HISTORIC AND DESIGN REVIEW COMMISSION

HDRC CASE NO: 2023-172
ADDRESS: 427 ADAMS ST
LEGAL DESCRIPTION: NCB 2880 BLK 5 LOT 7&8
ZONING: RM-4, H
CITY COUNCIL DIST.: 1
DISTRICT: King William
APPLICANT: Sue Ann Pemberton | Mainstreet Architects Inc.
OWNER: Richard and Elaine Lutton
TYPE OF WORK: Porch roof extension and shade structure construction
APPLICATION RECEIVED: April 28, 2023
60-DAY REVIEW: Not applicable due to City Council Emergency Orders
CASE MANAGER: Bryan Morales

REQUEST:

1. Construct a shade structure with a standing seam metal roof and tube steel posts in the backyard.
2. Alter the existing awing condition at the front porch. Two existing pillars will be lengthened into porch columns, and the awning will be extended to meet the new columns.

Date: APRIL 27 2023
Scale:
Drawn by:
Job Number: ###
Sheet Number:
A-1
Sheet ## of ###

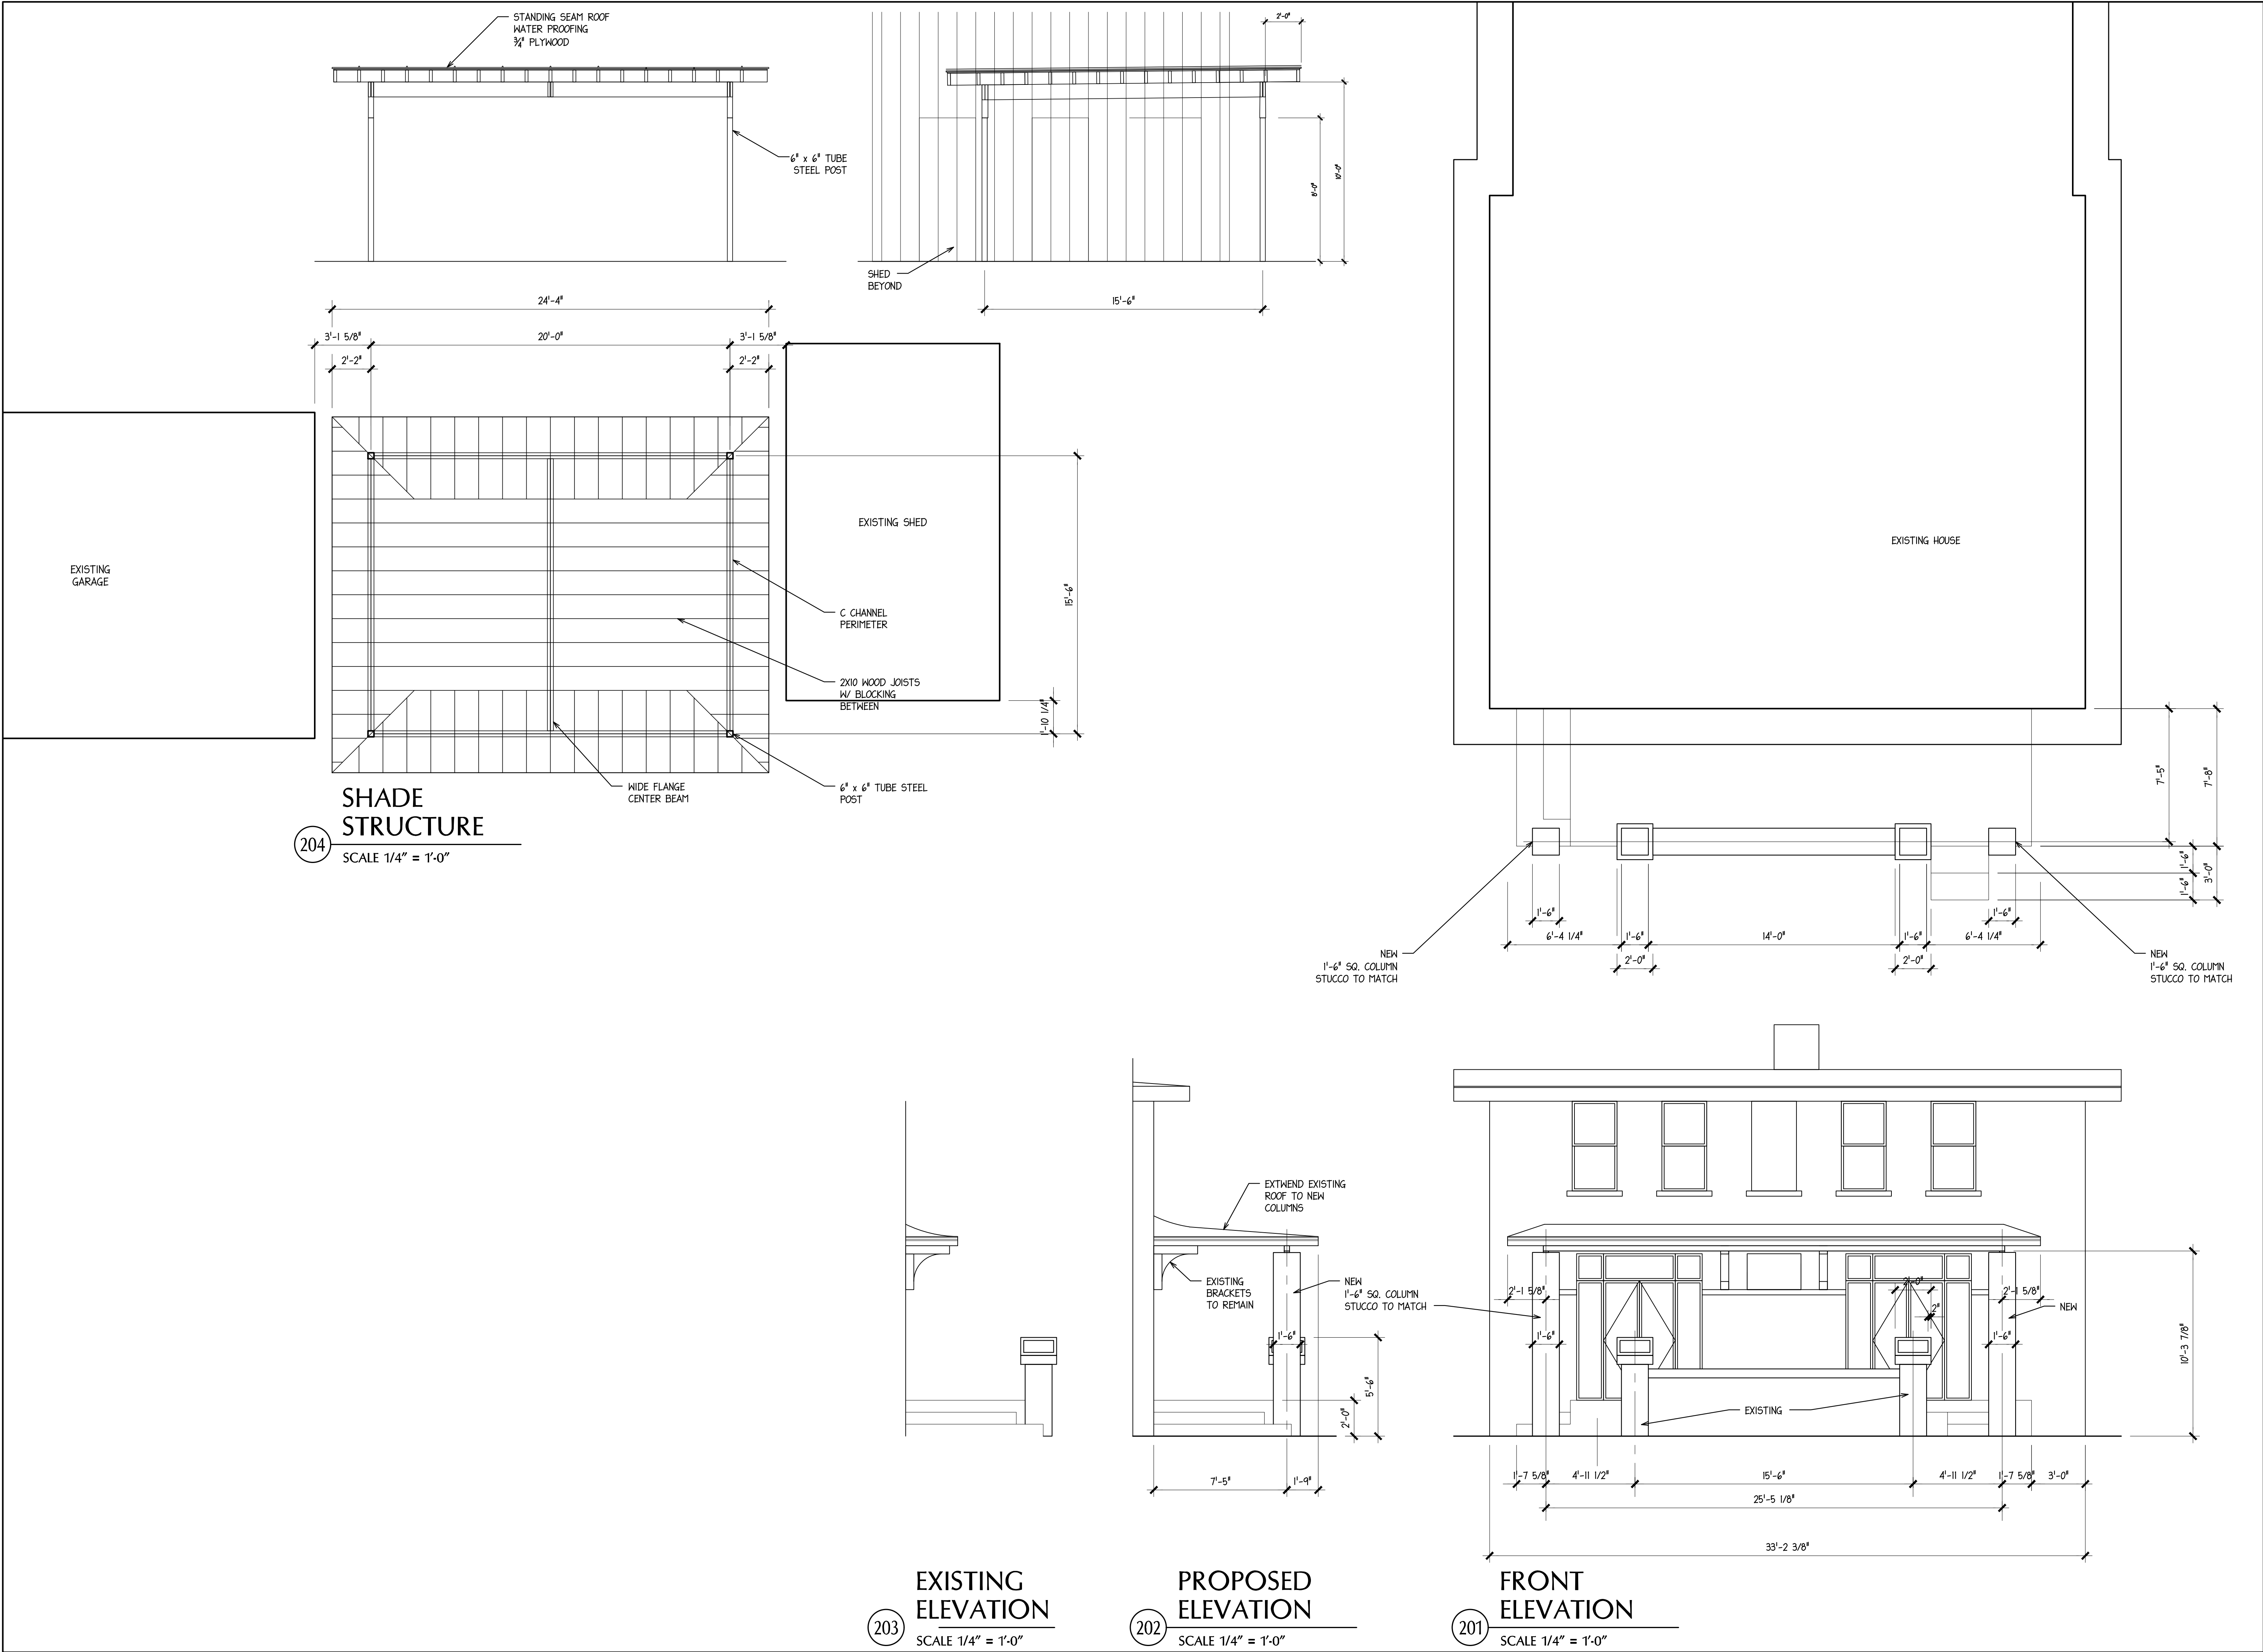
Do you know the measurements of how far the roof extends in each direction (i.e. the bird eye's footprint)?

Plan view, overall roof is 24'-4" x 19'-10", or 2'-2" from center line of column to edge of roof.
Sue Ann

Sheet Number:
A-2

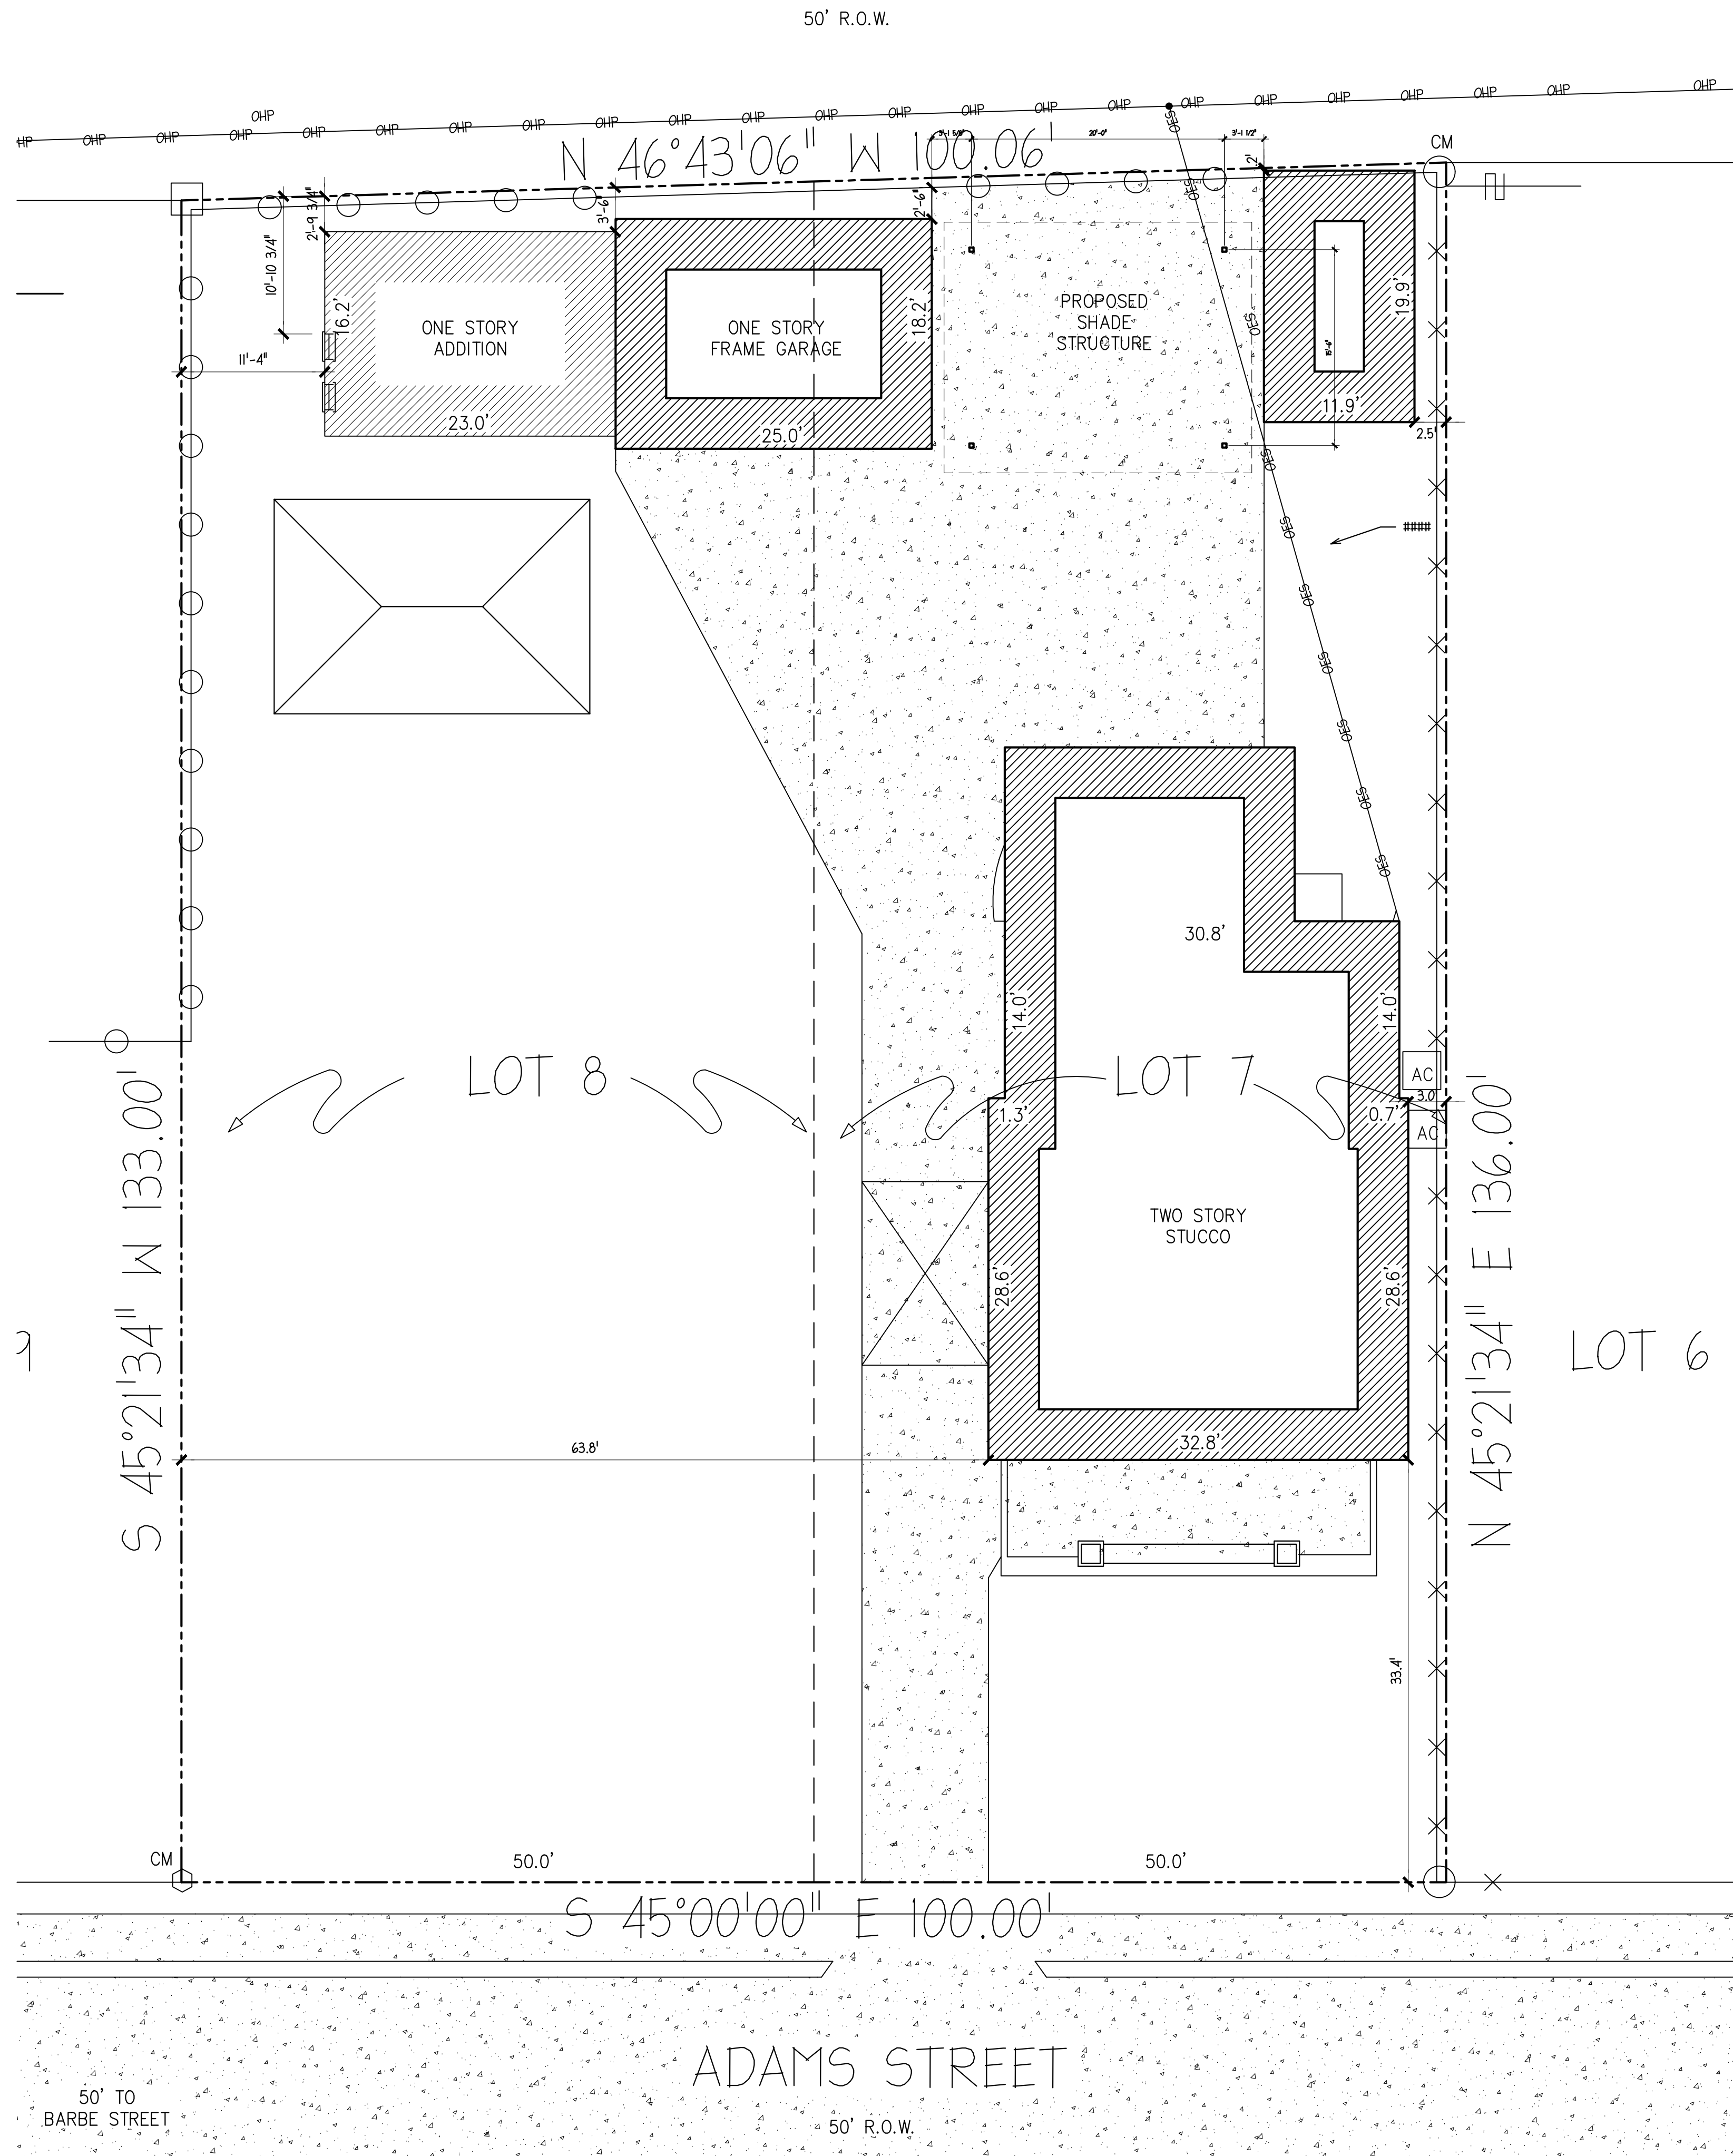
- b. **SHADE STRUCTURE** – The applicant is requesting to construct a 24'4" x 19'10" shade structure with a standing seam metal roof and 6x6" steel tube posts. The Historic Design Guidelines for New Construction 5.A.iii. stipulates to relate new outbuildings to the period of construction of the principal building on the lot through the use of complementary materials and simplified architectural details. Staff finds that the shade structure generally conforms to Guidelines; however, staff recommends the applicant use 6x6" wood column posts rather than the proposed 6x6" steel tube posts.

- d. **PORCH ROOF EXTENSION** – The applicant is requesting to extend the existing front porch roof towards the northeast. Exterior Maintenance and Alterations 3.B.ii. states to preserve the original shape, line, pitch, and overhang

of historic roofs. Exterior Maintenance and Alterations 7.A.i. states to preserve porches, balconies, and porte-cocheres. Staff finds the proposed porch roof extension does not conform to Guidelines.

- e. COLUMN MODIFICATIONS – The applicant is requesting to extend the existing stucco pillars from 5’6” to 10’ 3 7/8” in height. The Historic Design Guidelines for Exterior Maintenance and Alterations 7.B.iv. states to not add new elements and details that create a false historic appearance. Staff finds the proposed column modifications do not conform to Guidelines.

- i. That the applicant install a standing seam metal roof featuring panels that are 18 to 21 inches wide, seams that are 1 to 2 inches high, a crimped ridge seam, and match the current finish or a standard galvalume finish. Panels should be smooth without striation or corrugation. Ridges are to feature a double-munch or crimped ridge configuration; no vented ridge caps or end caps are allowed. All chimney, flue, and related existing roof details must be preserved. An inspection must be scheduled with OHP staff prior to the start of work to verify that the roofing material matches the approved specifications. No modifications to the roof pitch or roof form are requested or approved at this time.
- ii. That the applicant install 6x6” square wood columns rather than the proposed steel tube posts.

Staff does not recommend approval of item 2, based on findings d and e. Staff recommends that the applicant retain the historic front porch condition.
